In the Drawings:

Remarks

FIG. 1

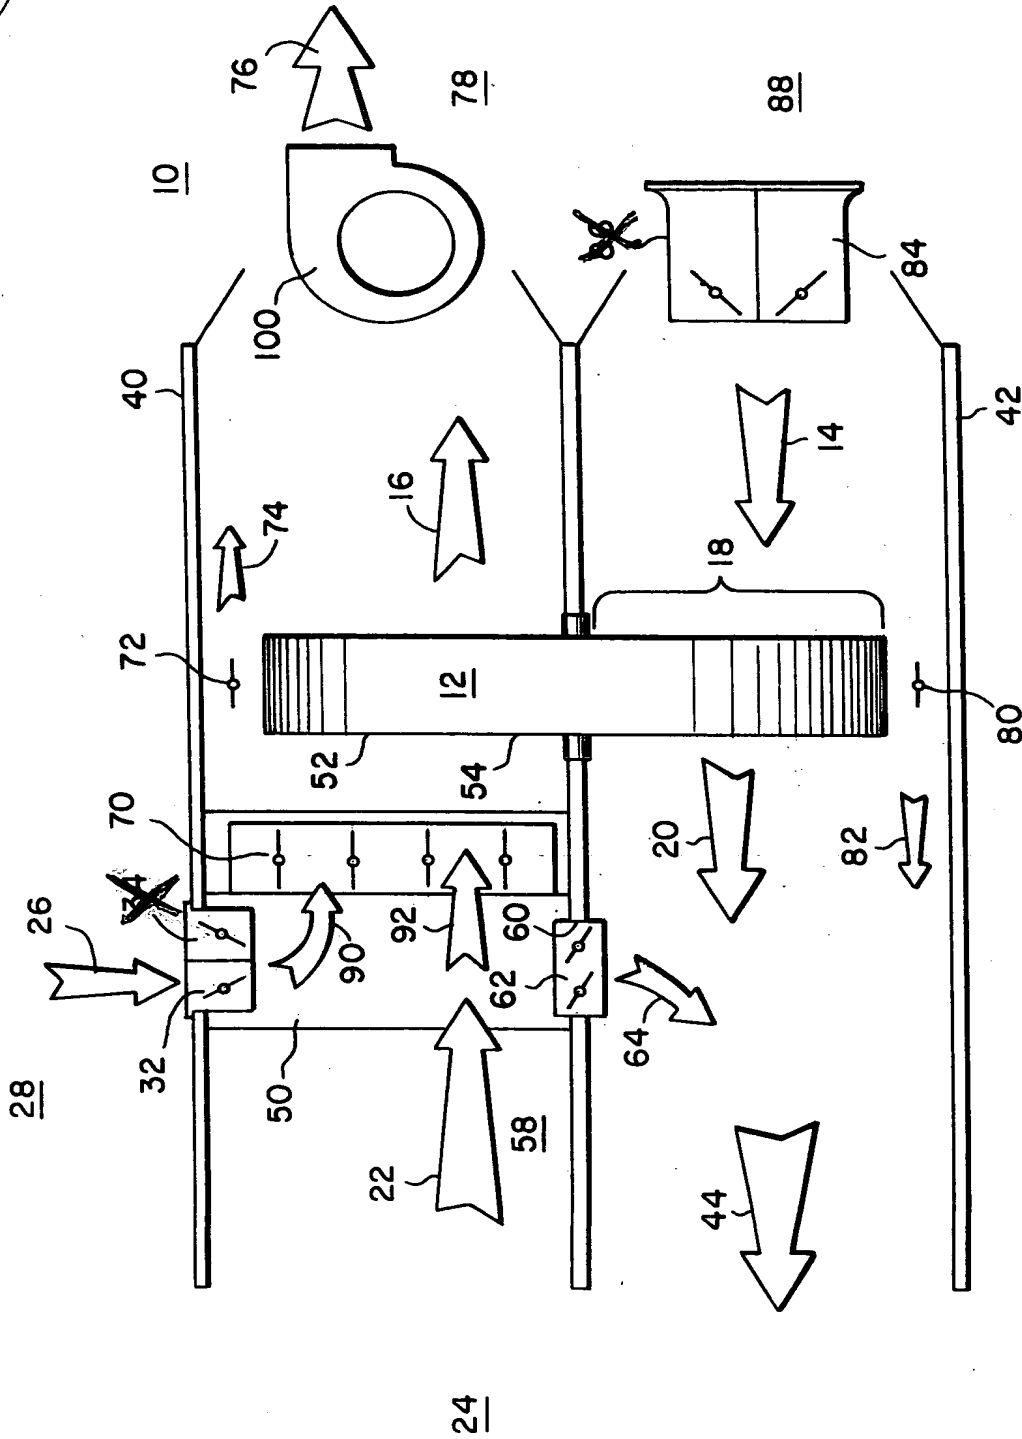
Replacement sheet 1 has been submitted deleting reference numerals 34 and 86 and their respective lead lines. A highlighted version of the drawings is also attached to show the deletion of reference numerals 34 and 86 and their lead lines from Figure 1. Inasmuch as the Figures 2 and 3 are believed to clearly show the damper and sensor relative to reference characters 32, 34, 84 and 86, the deletion of these reference characters from Figure 1 is believed to resolve the drawing objection raised in numbered paragraph 7.

Please submit the amended Drawing Figure 1, Sheet 1, attached hereto in place of the Drawing Figure 1, Sheet 1, currently on file.
